Town of Hilton Head Island
Design Review Board Special Meeting
Tuesday, September 8, 2020 – 1:15 p.m.
AGENDA

Town of Hilton Head Island
Design Review Board Special Meeting
Friday, August 21, 2020 at 9:00 a.m. Virtual Meeting
MEETING MINUTES

Re: Narrative Response to comments from July 24, 2020 Design Review Board Meeting DRB 001283-2020 Schooner Court

SCHOONER COURT 30 DRB SITE LAYOUT

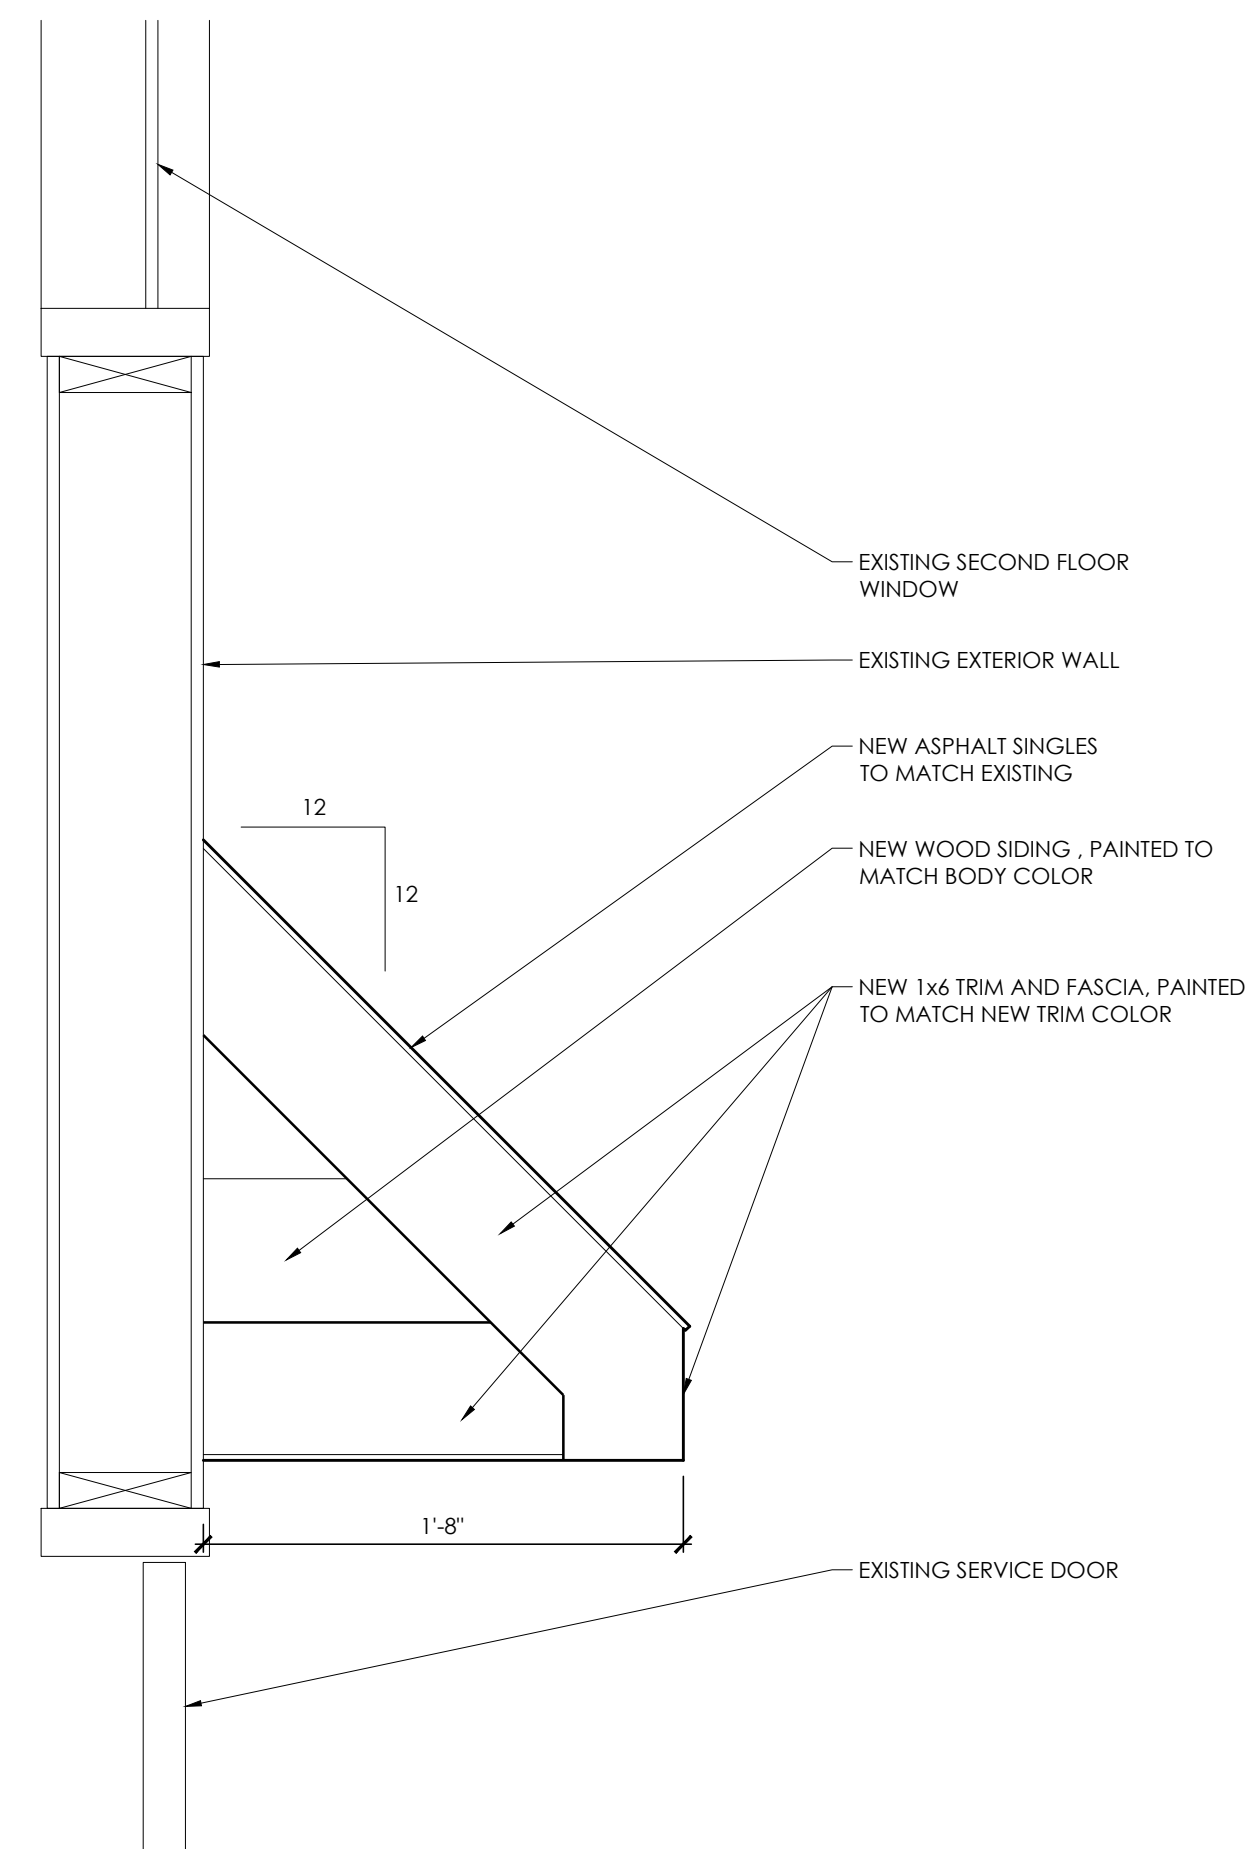
7. Provide directions to the wall painted with the proposed building colors so the DRB can review the colors on site.
 - a. **Response:** See 2D renderings and site plan for all building / unit colors. Painting mock-up can be viewed at 150 Light House Road parking lot wall adjacent to unit 709 Schooner Court. Call Jim Cantalupo 704-577-6699 for gate pass into Sea Pines.

NEW BALCONY CABLE RAILING DETAIL

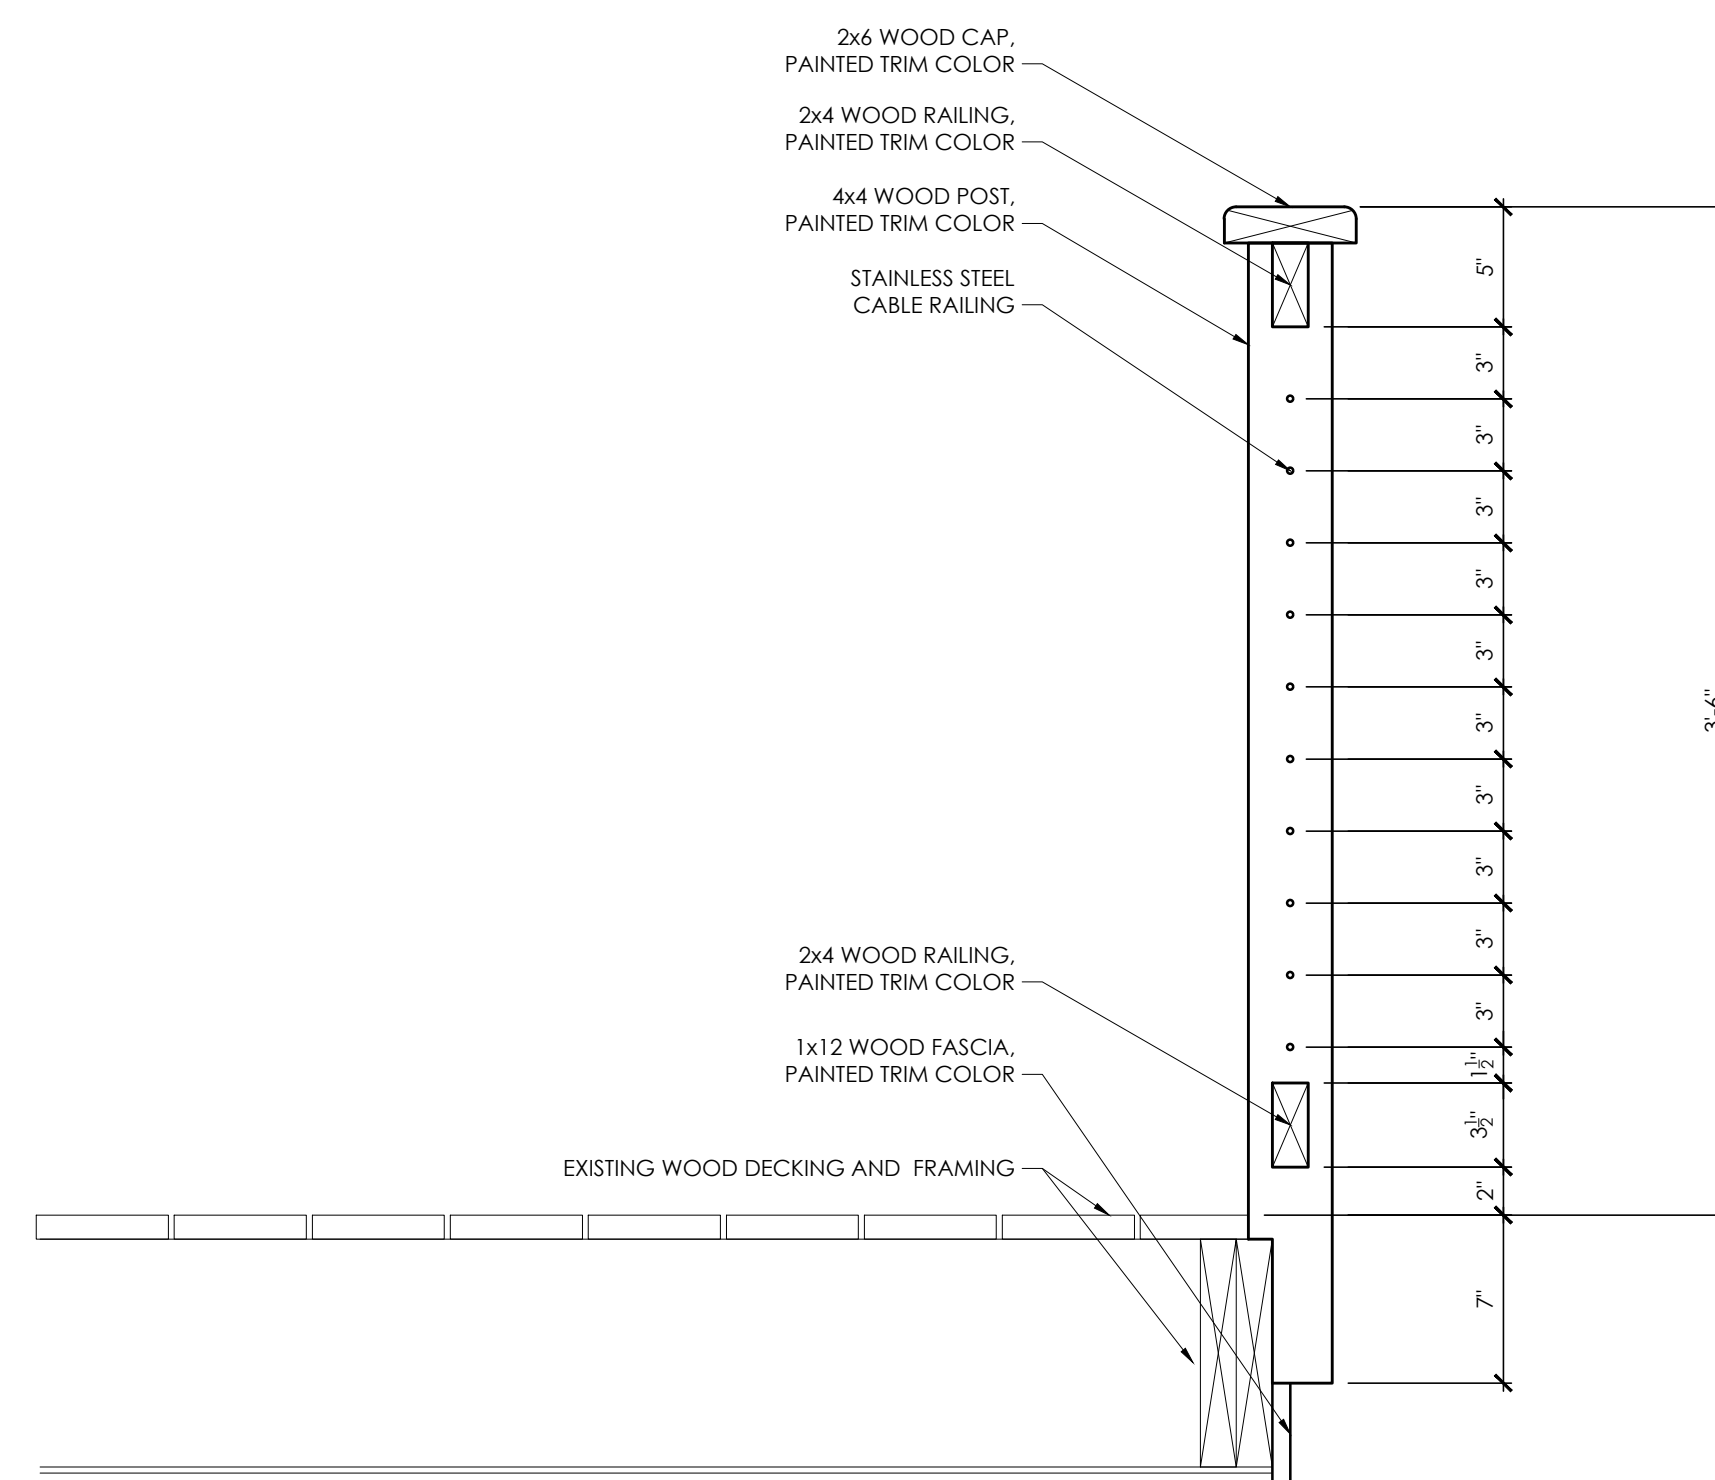
4. Provide colors for the trim, soffit, fascia, and balcony railings.
 - a. **Response:** The trim, soffit, fascia, and balcony railings are to be painted the trim color of the respective units. See 2D renderings and new balcony railing detail.

NEW SERVICE YARD FENCE PLAN DETAIL

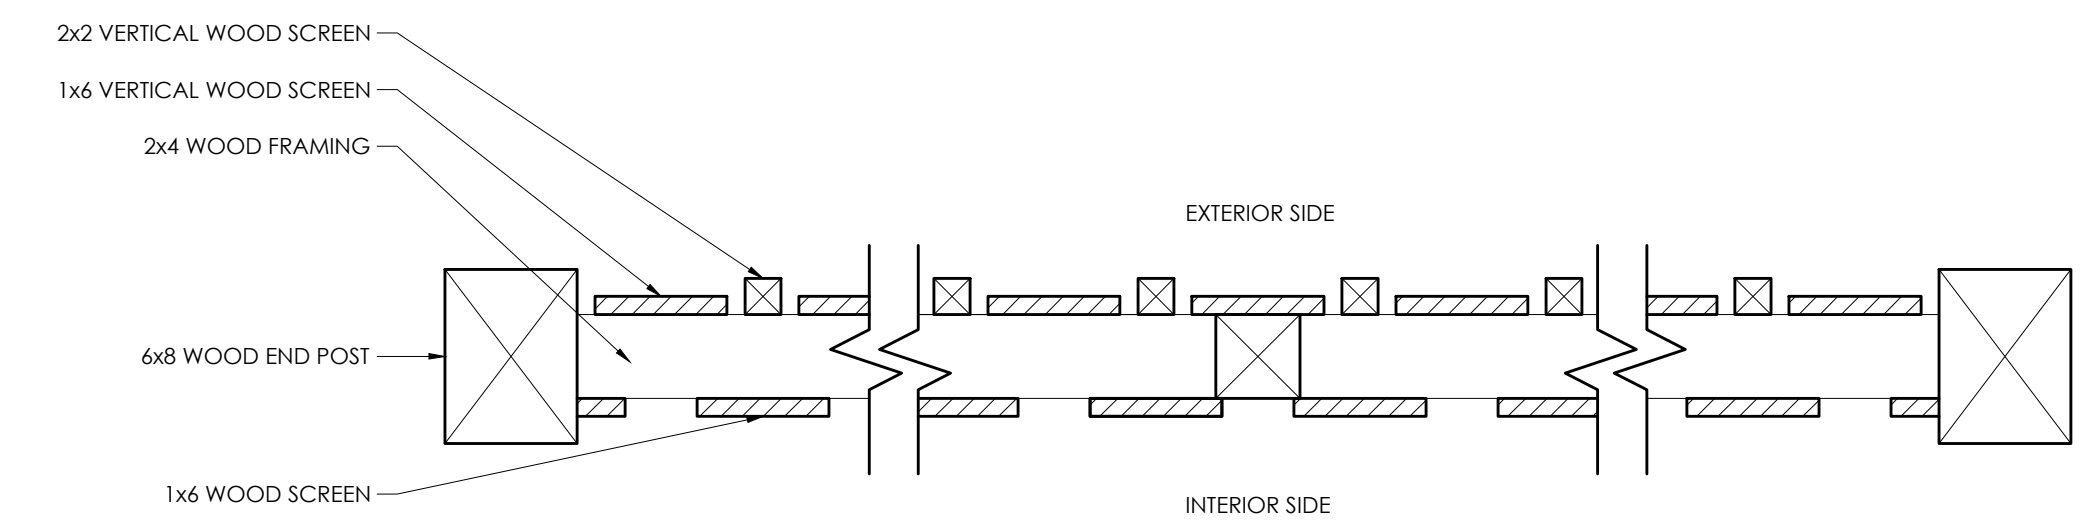
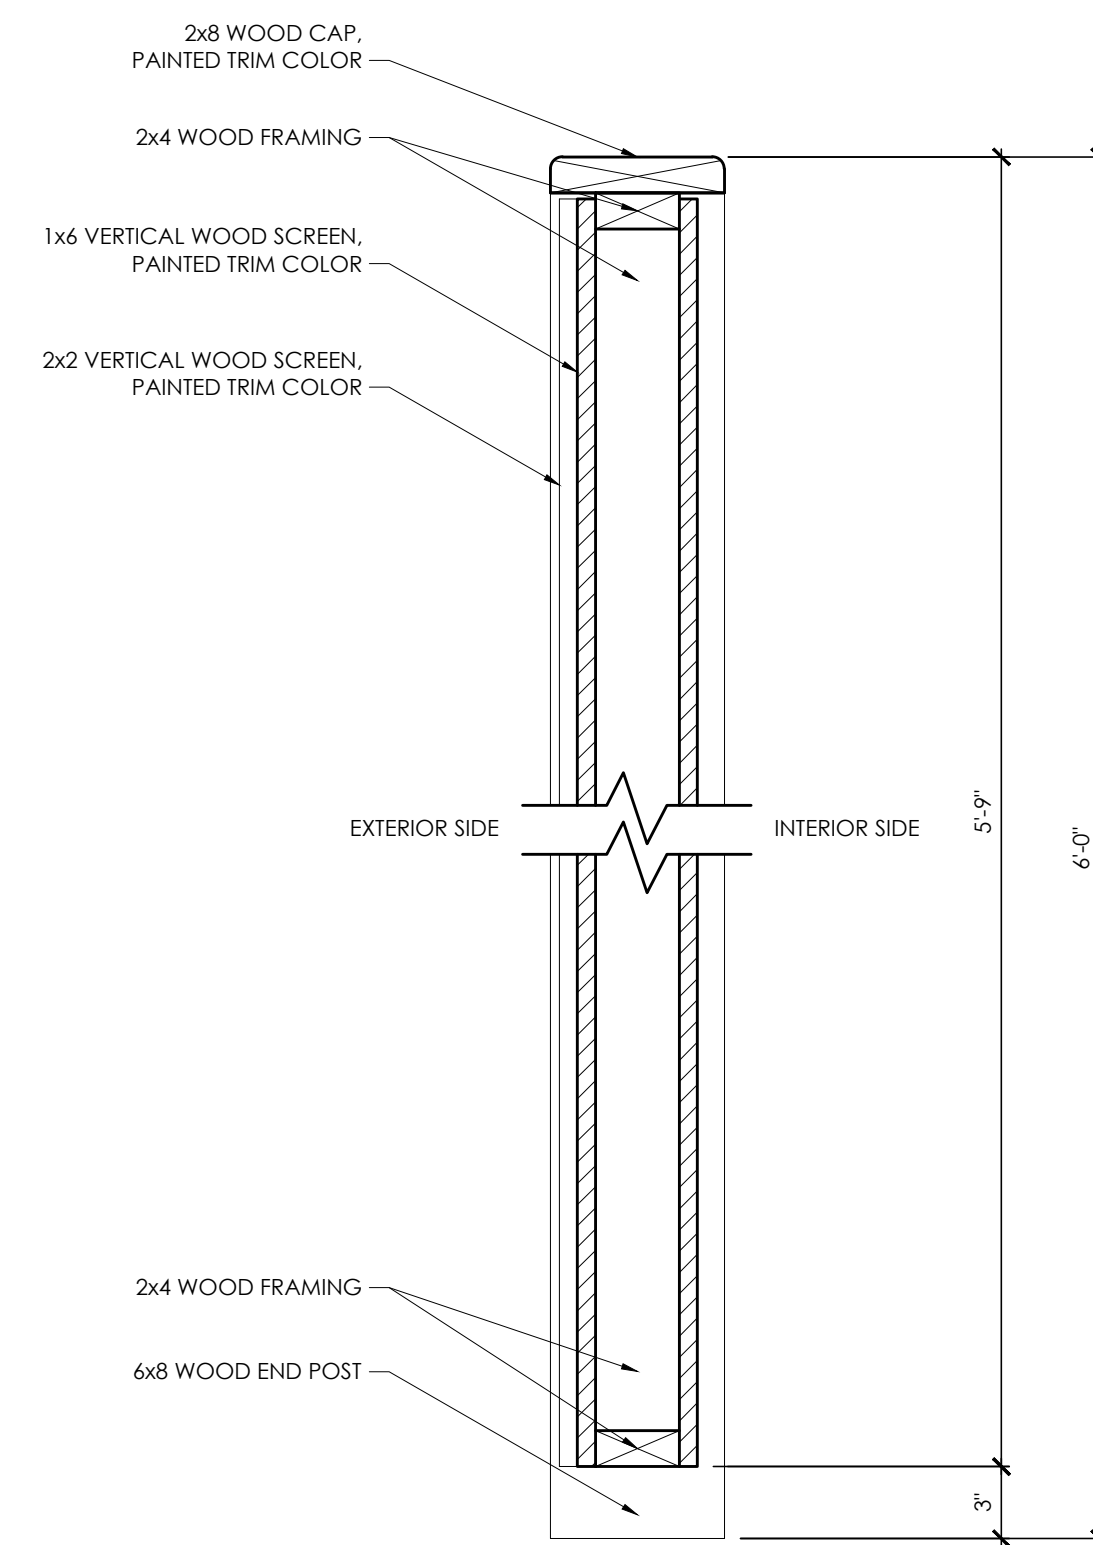
3. Include proposed color or colors for the service yard fences. This may be accompanied by a schedule to complete this part of the work.
 - a. **Response:** The service yard fences are to be painted the trim color of the respective unit. See 2D renderings and new service yard fence detail.

1. Change all service yard fence colors to SW 6142 Macadamia.
2. Satisfy the DRB's question regarding the different roof colors.

1. Staff is concerned that the translation of the different building colors into the service yard fences may come off as cartoonish. Because the wooden service yard fence is a different material from the stucco building it would suggest a different compatible color for the fence. With the proposed diversity of building colors, a single fence color compatible with all the building colors would serve to bring the development together, or in other words provide a harmonious setting for the buildings. An earthtone service yard fence would be a nod to the color scheme preferred in the Design Guide (page 16, "Color: Context") while still honoring the Portafino inspiration of Harbor Town, also noted in the Design Guide (page 14, "Context").
